U.S. Department of Energy
Office of River Protection

04-WTP-268

U.S. DEPARTMENT OF ENERGY (DOE), OFFICE OF RIVER PROTECTION (ORP)
RESPONSES TO THE DEFENSE NUCLEAR FACILITIES SAFETY BOARD (DNFSB)
CONCERNS

Responses to Issues Raised in July 21, 2004 Defense Nuclear Facilities Safety Board (DNFSB) Letter Regarding Waste Treatment and Immobilization Plant (WTP) Ventilation Systems Design

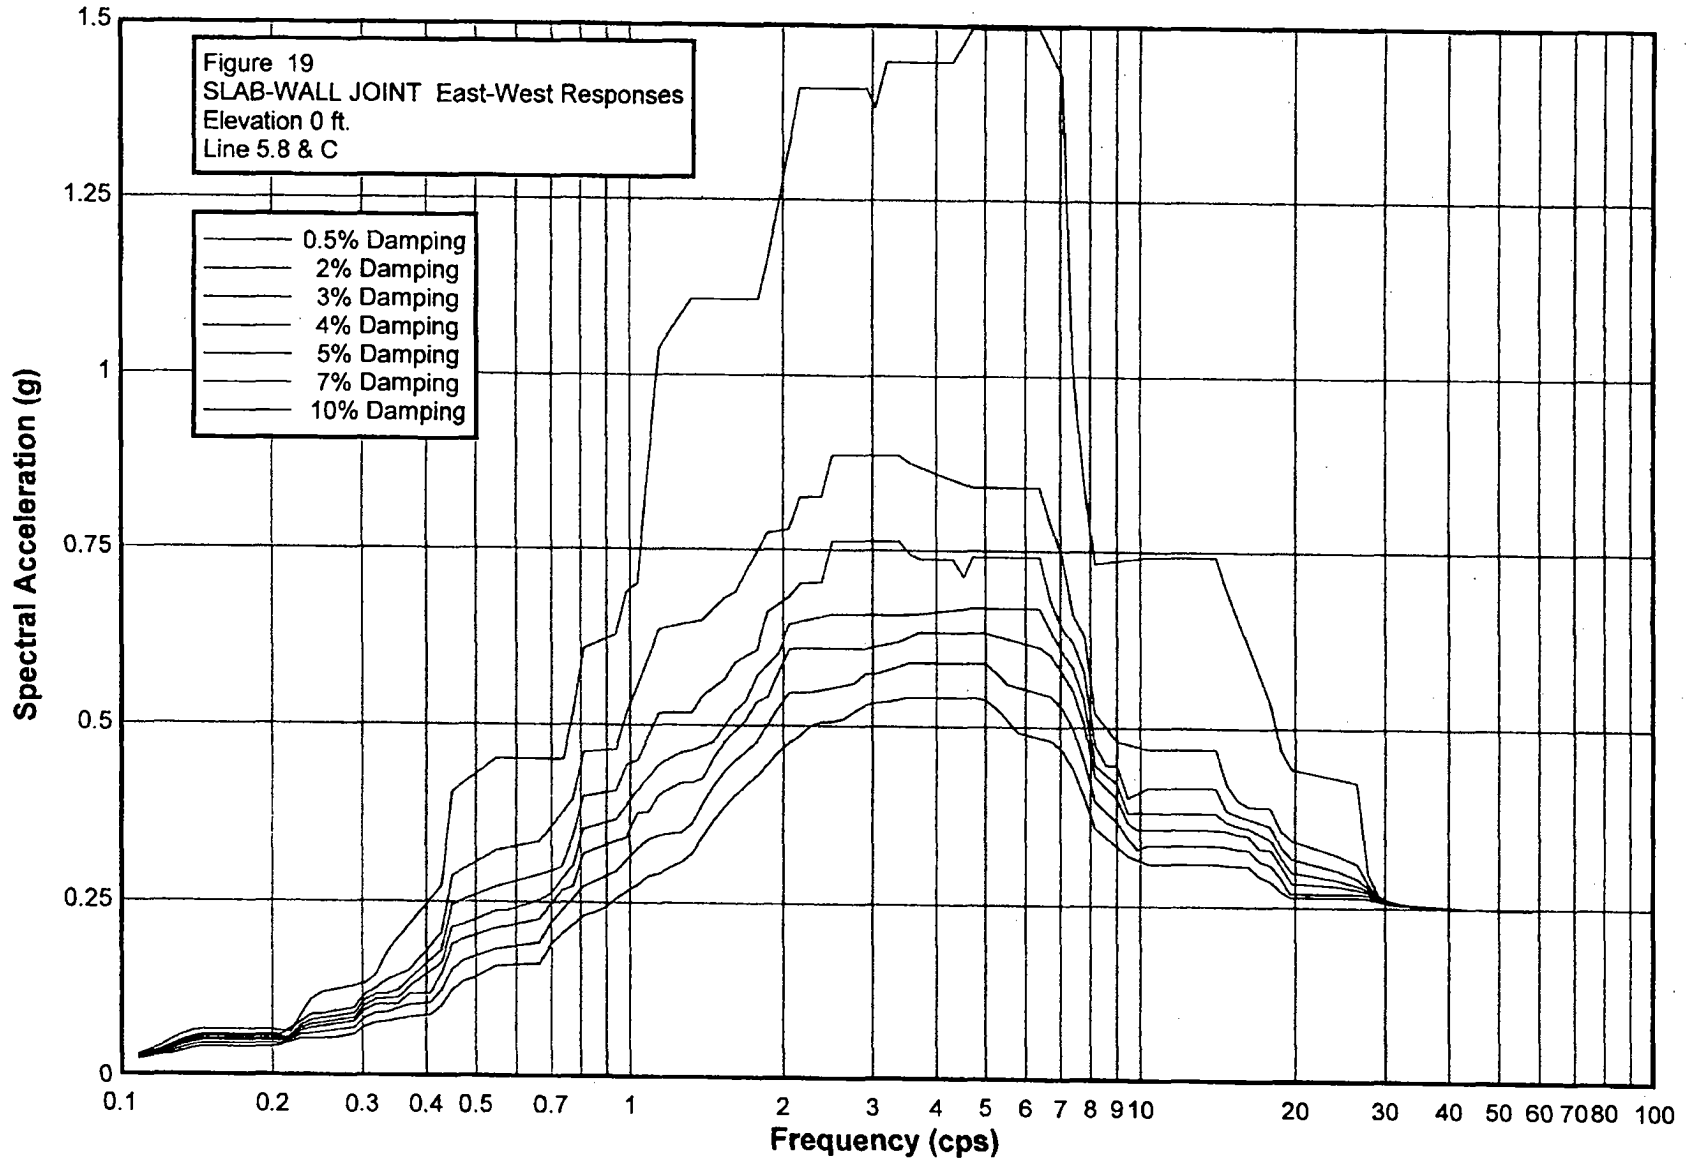
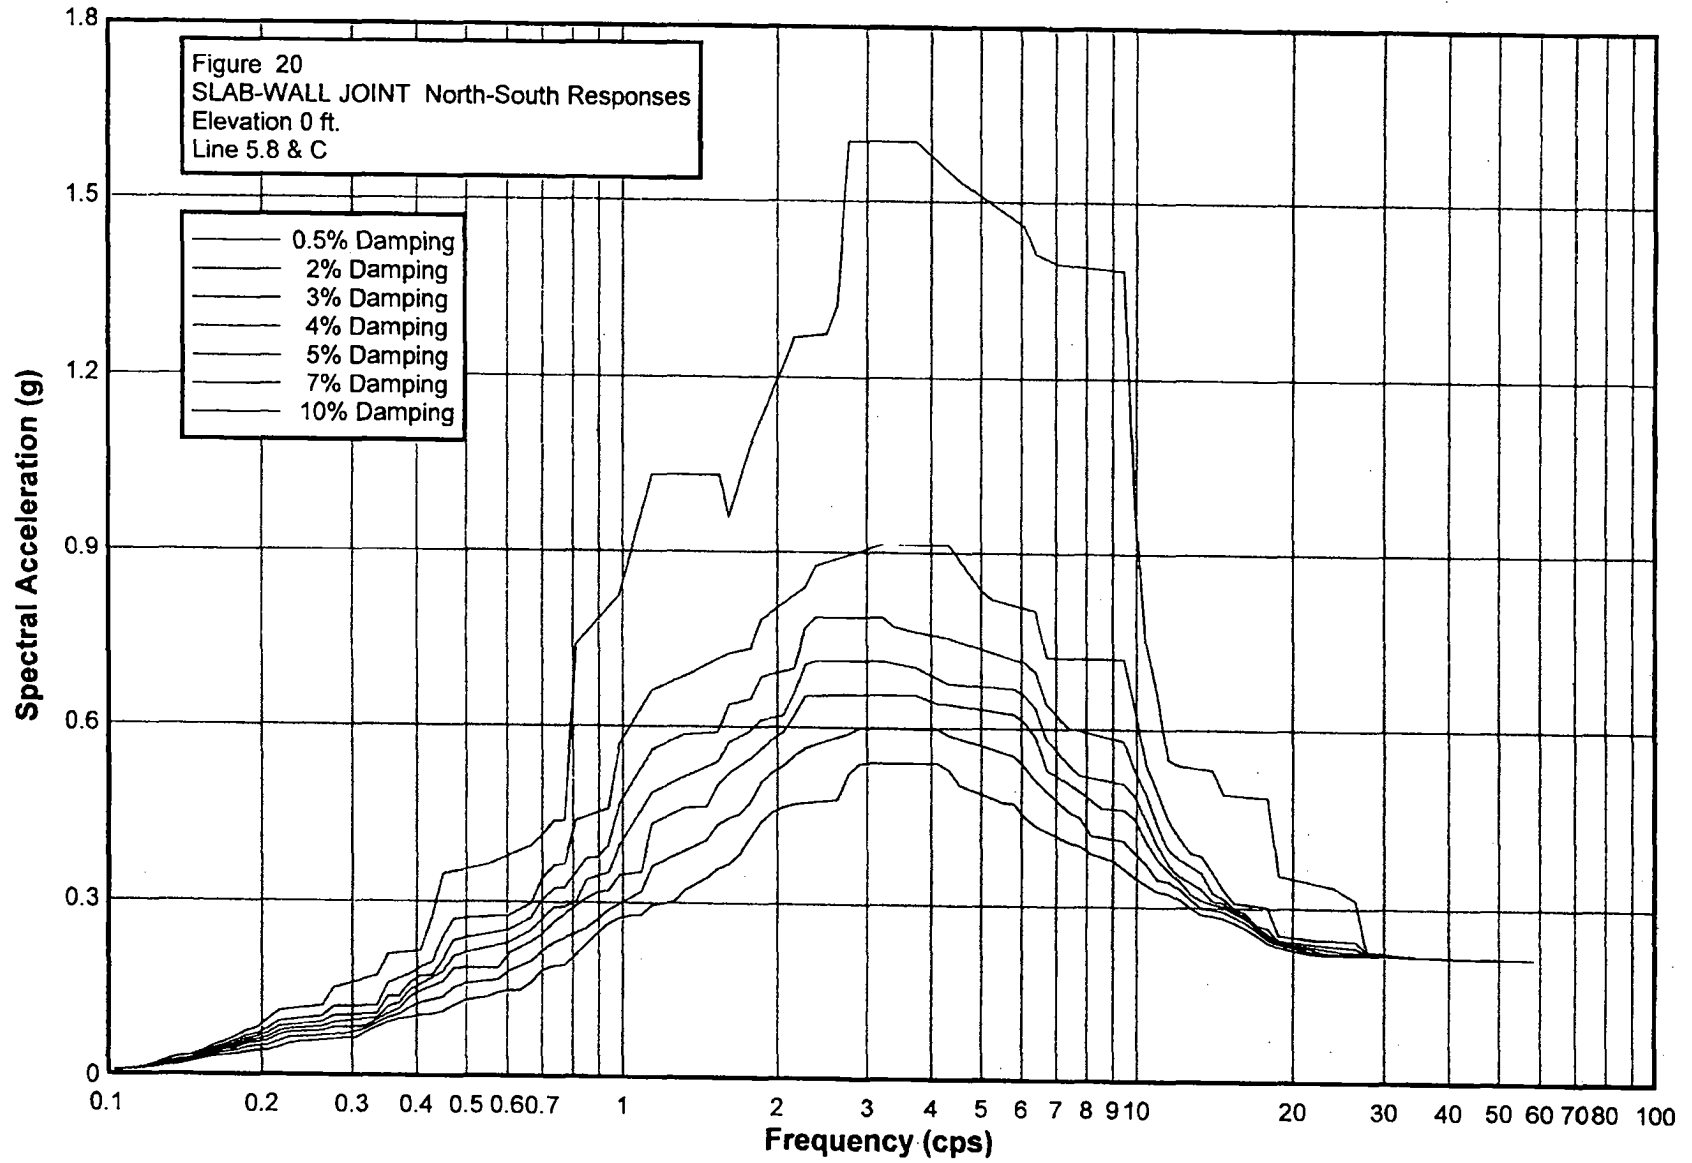
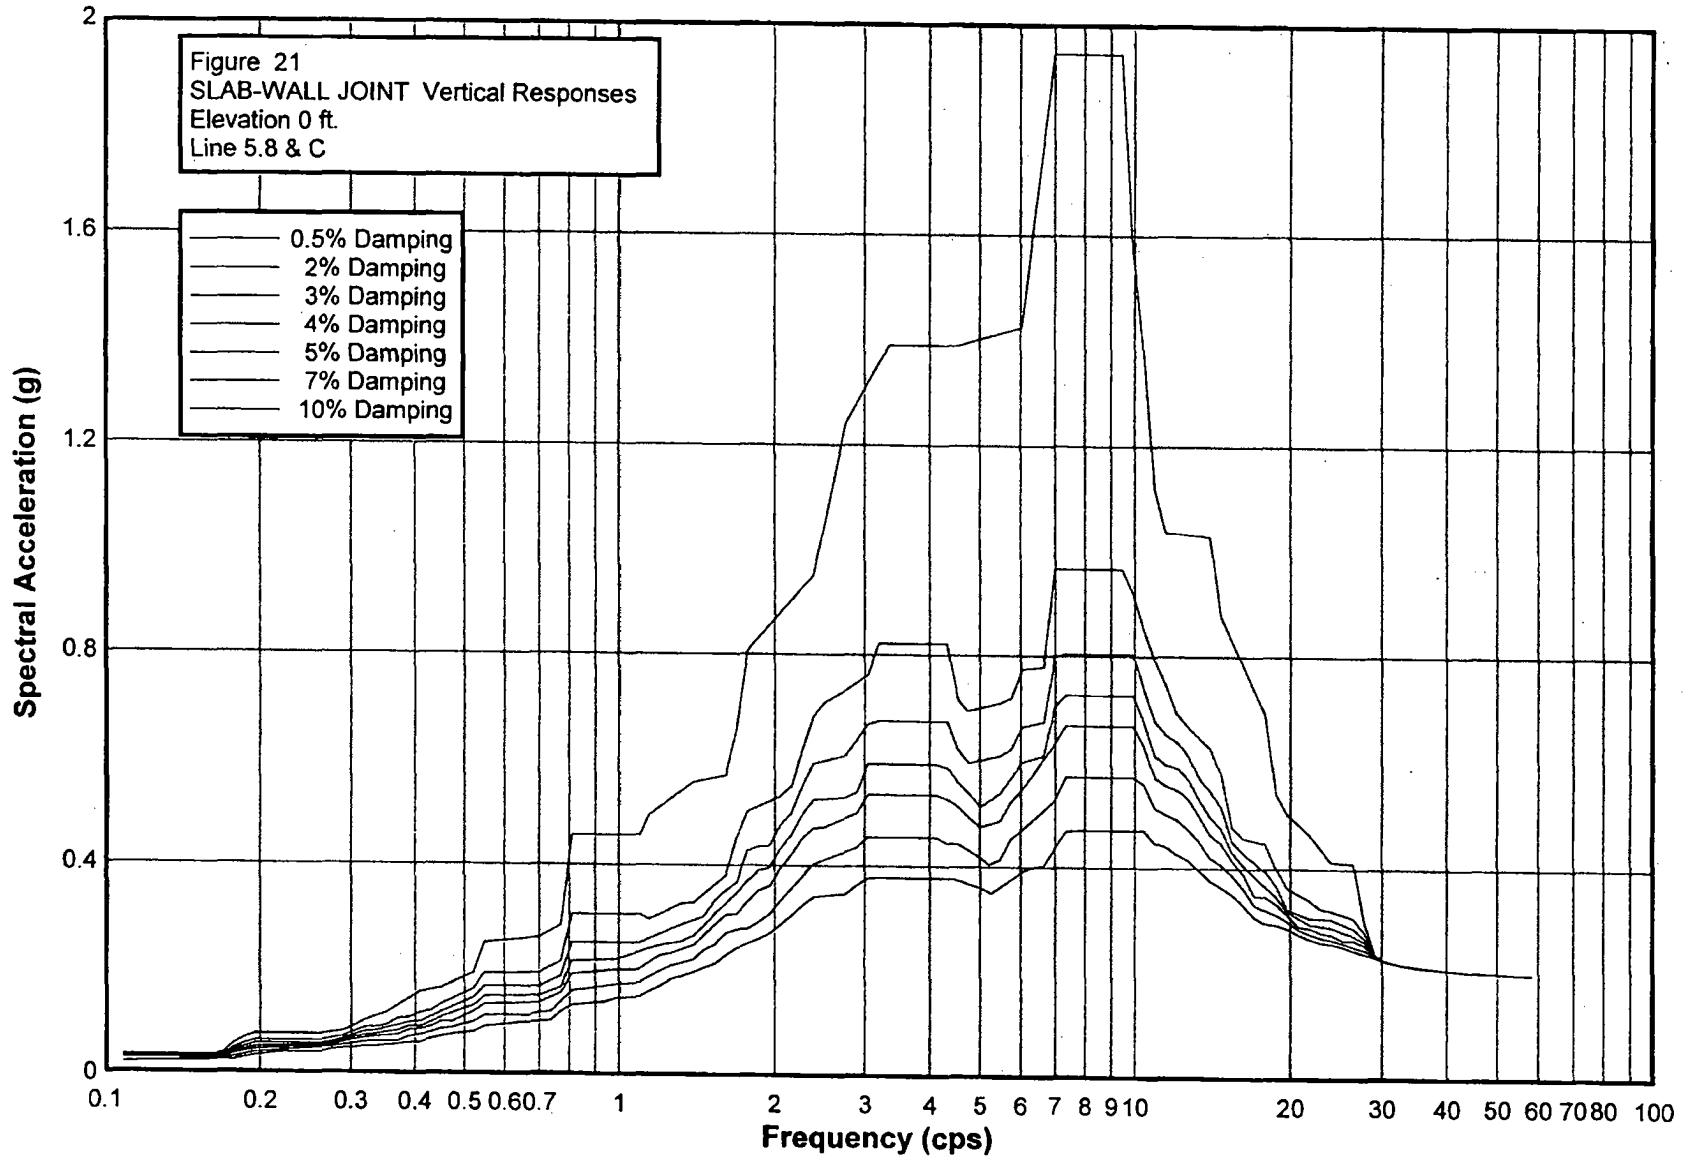
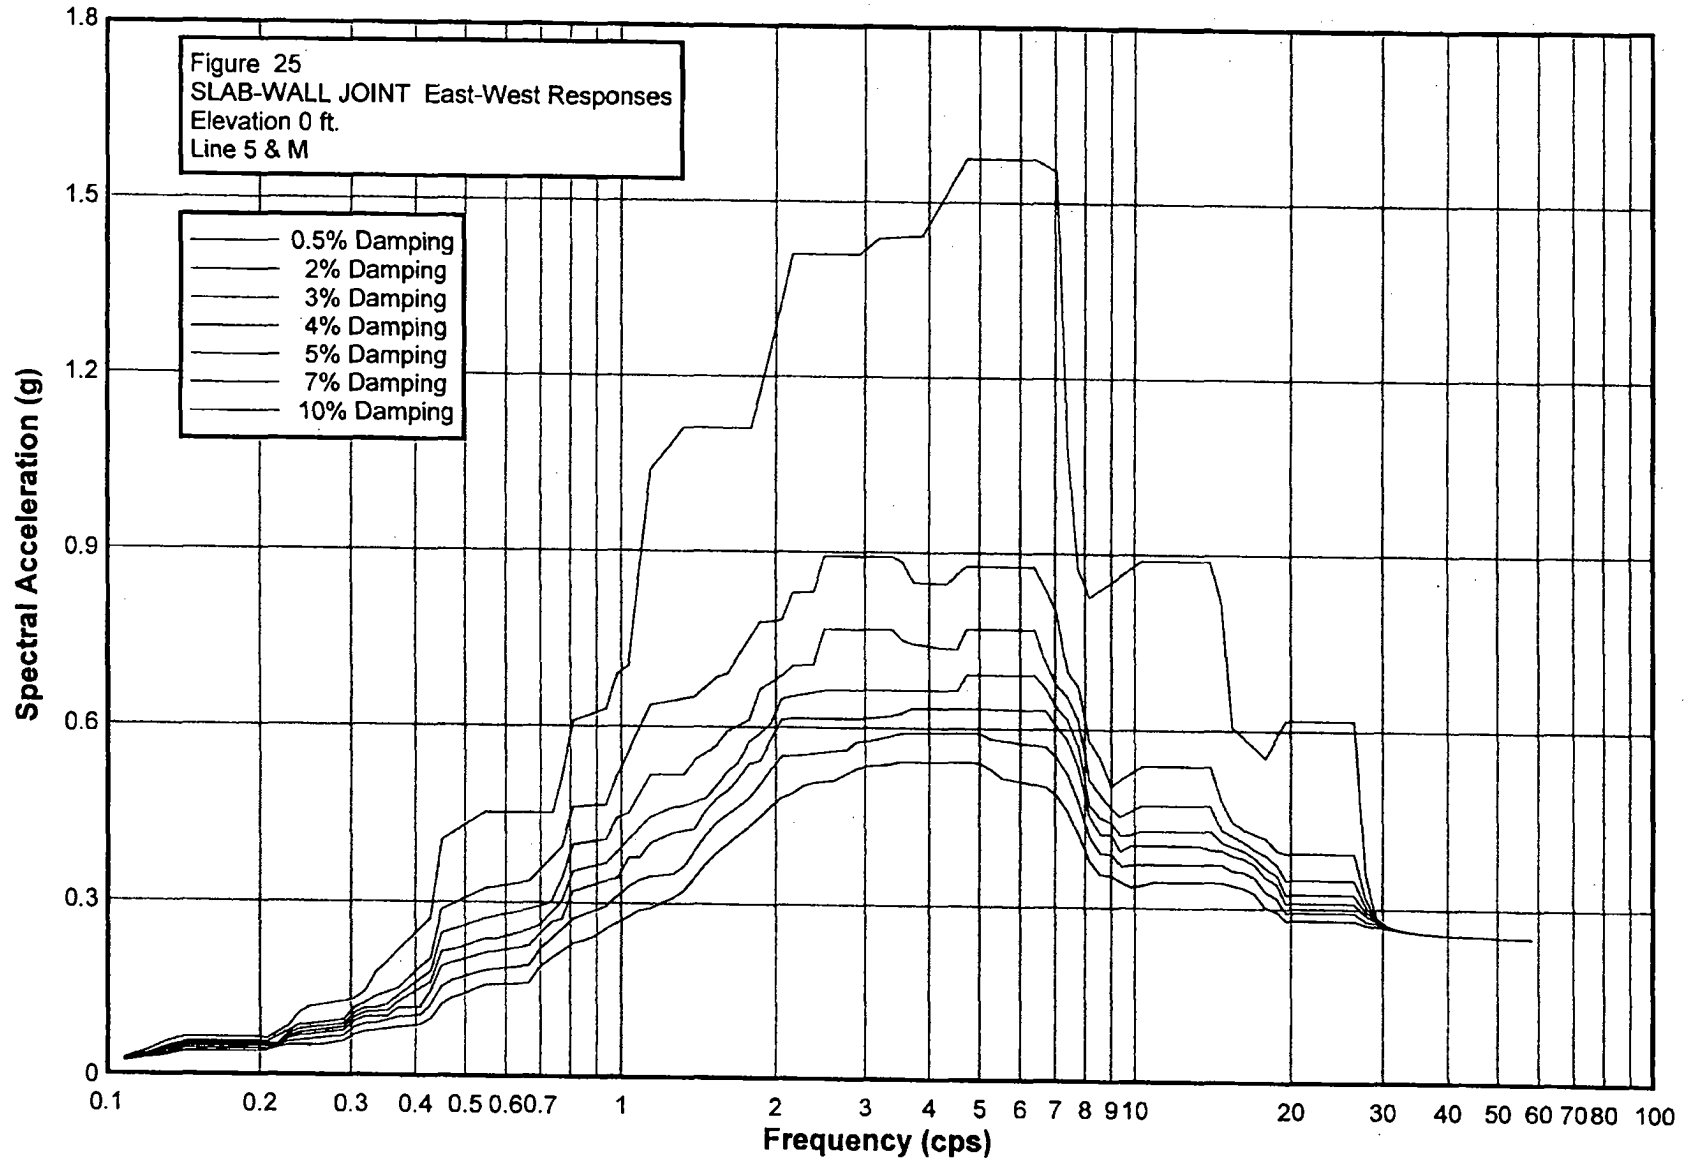
WTP-04-281-02 The planned ventilation filter housing shaker table tests will use a bounding seismic spectra as input for the shaker table tests. The staff wants to review the bounding data for suitability.

Response: The WTP Project will not use bounding data for the PT and HLW facilities. The specific In-Structure Response Spectra (ISRS) curves for each facility will be used and separate testing for each facility will be conducted. The applicable curves, by elevation and column line, for the Remote Change HEPA Filter housings will be used which shows the expected frequencies and accelerations in the north/south, east/west, and vertical directions. The reason for applying the ISRS curves specific to each building and not using bounding data is as follows:

Enclosed are the ISRS curves applicable to the Remote Change HEPA Filter housings in the HLW and PTF facilities.+
